SUBJECT: RECALL R12VR BRAKE LIGHT SWITCH MOUNTING BRACKET

REPLACEMENT

### Models Affected: Certain 2013 AND 2014 Model Year Propane Vision Buses **Equipped with Ford 6.8L Engines**

## Service Brake Light Switch Mounting Bracket Replacement

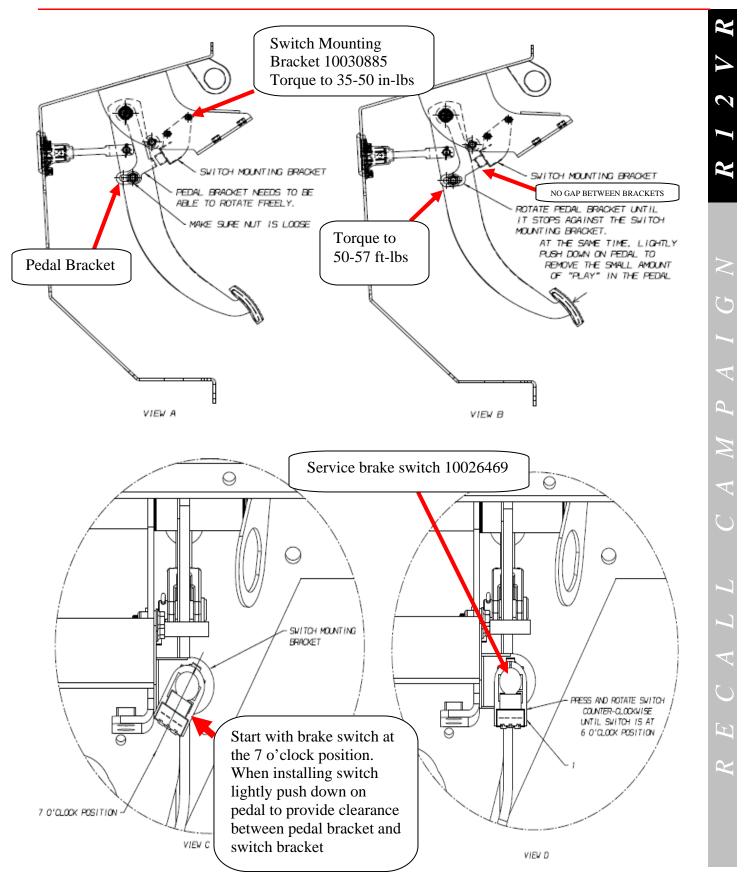
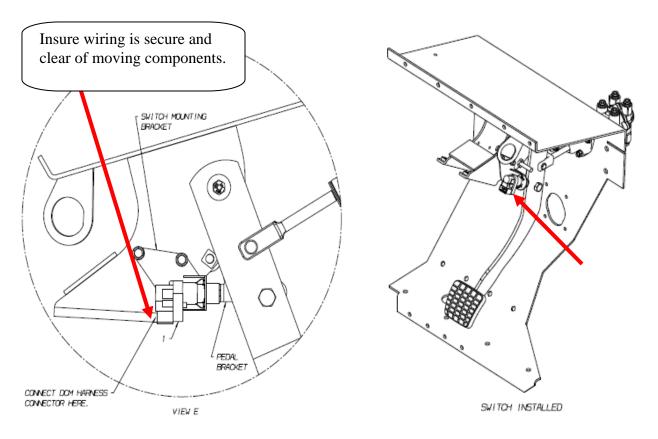
On affected models the brake light switch mounting bracket may have caused the brake light switch to be incorrectly adjusted at installation. This can result in the service brake lamps remaining on without the service brake applied.

The service brake switch mounting bracket must be replaced and adjusted per the following instructions. A new service brake switch will also be provided.

- 3. Remove existing service brake switch and mounting bracket. See "Switch Installed" detail for location of switch and bracket. Note: New switch should NOT be installed until new bracket is installed and adjusted.

- 4. Install new switch mounting bracket. See "View A". Tighten switch mounting bracket fasteners to a torque of 35-50 in-lbs. Loosen lower nut securing pedal bracket so pedal bracket can rotate freely as indicated in "View A".

- 5. While lightly pushing down on the pedal to remove the small amount of "play" in the pedal linkage, rotate pedal bracket until it stops against the switch mounting bracket. Tighten bolt on pedal bracket to a torque of 50-57 ft-lbs. See "View B".

- 7. Install new switch by lightly pushing down on the brake pedal to allow clearance for switch installation. Insert new brake switch into the switch mounting bracket with the connector at the 7:00 o'clock position. See "View C".

- 8. At the same time press and turn switch counter-clockwise until switch connector tabs lock into the mounting bracket at the 6:00 o'clock position. Switch self adjusts during this step. See "View D".

- 9. Reconnect DCM wiring harness connector to service brake switch. See "View E".
- 10. Apply service brake pedal and verify service brake lamps are on when applied and off when service brake pedal is released.
